TRANS/WP.29/GRE/2003/24  
1 July 2003

PROPOSAL FOR DRAFT AMENDMENTS TO REGULATION No. 112

(Headlamps emitting an asymmetrical passing beam)

Figure 1:

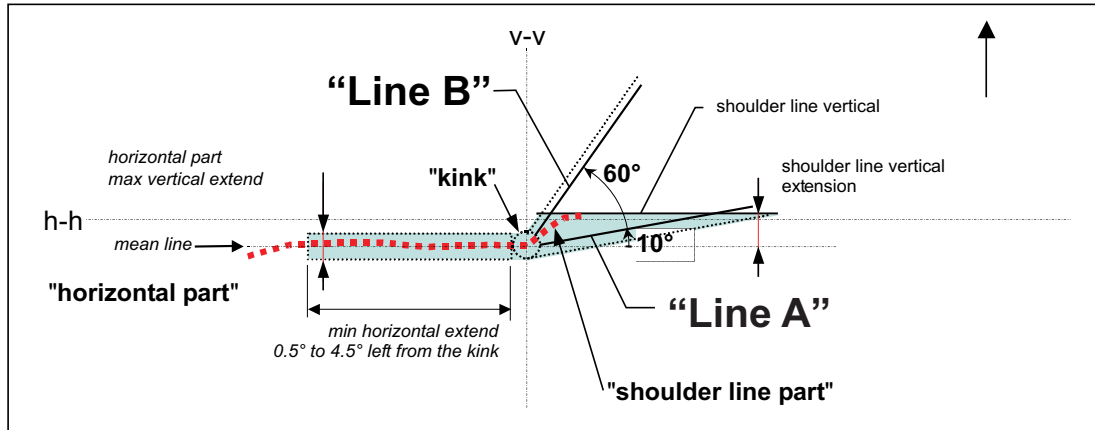
For visual adjustment of the passing beam the cut-off line shall provide a horizontal line for vertical adjustment of the headlamp between  $0.5^\circ$  and  $4.5^\circ$  distant from the v-v-line (see Figure 1), which does not exceed a vertical extend of  $\Delta\beta = 0.2$  degree up or down.

Figure 2:

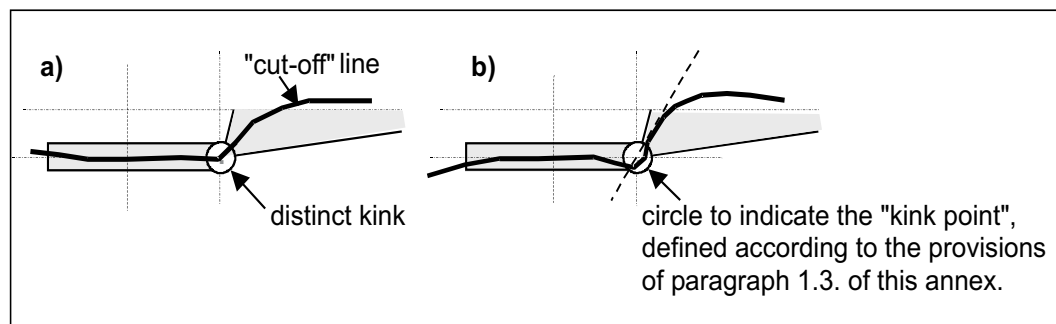
The beam with its the "cut-off" line shall be moved from right to left (left hand traffic: from left to right) until the "kink" or "elbow" is situated at the v-v-line. If the "elbow" forms no sharp enough edge, that point shall be taken, where the horizontal line through the straight part and the steepest tangential line onto the shoulder part of the cut-off line are crossing (for examples see Figure 2). The "shoulder line part"

- (a) does not extend the tangential line "B" going from the "kink" upwards to the right and being inclined versus h-h by 60°;
- (b) does not extend the tangential line "A" going from the "kink" upwards to the right and being inclined versus h-h by 10°;
- (c) has a vertical extension of at least  $\Delta\beta = 0.57^\circ$  over a distance of  $2^\circ$  to the left (right hand traffic) and  $2^\circ$  to the right (left hand traffic).

Figure 3:

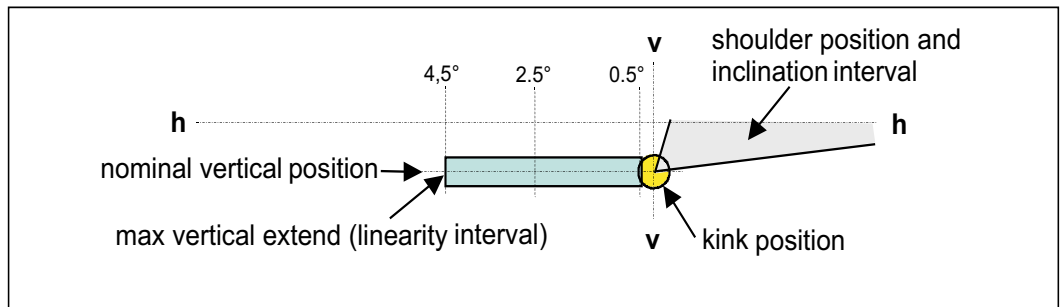
The part of the cut-off line which serves vertical adjustment shall be horizontal between 0.5° and 4.5° distant from the v-v-line. This requirement is deemed to be met when the vertical position of the inflection points (where  $d^2(\log E) / d\beta^2 = 0$ ) at 1.5°, 2.5° and 3.5° horizontal distance from the v-v-line are located within a band width of +0.2° from the nominal vertical position of the cut-off line at 2.5° sideward of the v-v-line, see Figure 3.
